# Office Action Summary

10/563,348

SCHANZ ET AL.

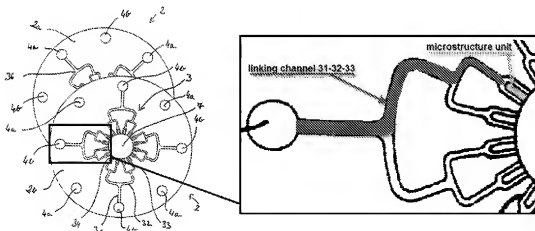
3. Regarding the first pages of Applicants' Remarks (p 9 para 4-p 10 para 2), Applicants are directed to paragraph 6 of the prior action for reference to the microstructure units recited in the claims: although a subset of these units and a different channel are identified in the rejections below to conform to the claim amendments, the structure is similar. Regarding the last paragraph of p 12, Applicants' disclosure does not supply an explicit definition of "microstructure unit", but rather a description of desirable properties a "microstructure part" might have. Where the specification does explicitly discuss the term "microstructure unit", it is to note that "The microstructure units, however, can also be linear, unbent or have any other geometric shape" (Specification 9/19/07 p 7, lines 4-5 from the bottom). The raised structure

separating the part channels 32 of Ehrfeld (figure 3a) is a physical structure, the outer walls of which define the inner walls of part channels 32. Since it is part of a disk taught for use in a micromixer (Ehrfeld: title, claims 1-22), it may be reasonably be called a "microstructure unit", and so unquestionably is included in the scope of Applicants' claims.

4. Regarding page 10 (paras 3-4) of the Remarks, channel 31 and each leg of channels 32 may reasonably be considered a channel which may be identified as different from each other, despite the absence of valves or physical dividers between them; as may the linking channel 31-32-33 and the part channels 34 referred to in the rejections below. The Bristol Channel, St George's Channel, and the Irish Channel (Straits of Moyle) circling around the western coast of Great Britain have no barrier preventing their fluid communication: they flow one into the other sequentially, but are given separate names because they can be separately identified upon a map. The Arkansas River and White River bifurcating off the Mississippi River in the state of Arkansas were considered separate channels for the centuries after they first received those names, long before the introduction of locks and barriers which partly separated them in modern times.

8. With regard to claim 1, Ehrfeld et al teach a component for a static micromixer (figure 3a) in the form of a disk (2a) comprising at least one inlet opening (4b) for the introduction of at least one feed stream into a linking channel (31-32-33, see attached annotated figure 3a) disposed in the plane of the disk and at least one outlet opening,

the outlets of part channels (34), for the outflow of the feed stream into a mixing zone (7) disposed in the plane of the disk, wherein the inlet opening (4b) is connected with the outlet opening in a communicating manner through the linking channel (31-32-33) disposed in the plane of the disk, and wherein the linking channel (31-32-33) immediately before opening into the mixing zone (7) is divided by microstructure units, the unnumbered raised portions between part channels 34, into two or more part channels (34), the widths of the part channels being smaller than the width of the mixing zone (7) (figure 3a, para 51). Ehrfeld et al does not explicitly teach that the widths of the part channels be in the millimeter to submillimeter range: however, it would have been obvious to one of ordinary skill in the art to manufacture the disk of Ehrfeld et al so that all its channels be of millimeter to submillimeter range: the motivation would have been the teaching by Ehrfeld et al that they disclose a "Micromixer", as their invention is titled. Alternatively, it has been held that where the only difference between a claimed invention and the prior art was a recitation of relative dimensions of the claimed device, and a device having the claimed relative dimensions would not perform differently than the prior art device, the claimed device is not patentably distinct from the prior art device. See *Gardner v. TEC Systems, Inc.*, 725 F.2d 1338, 220 USPQ 777 (Fed. Cir. 1984), *cert. denied*, 469 U.S. 830, 225 USPQ 232 (1984).
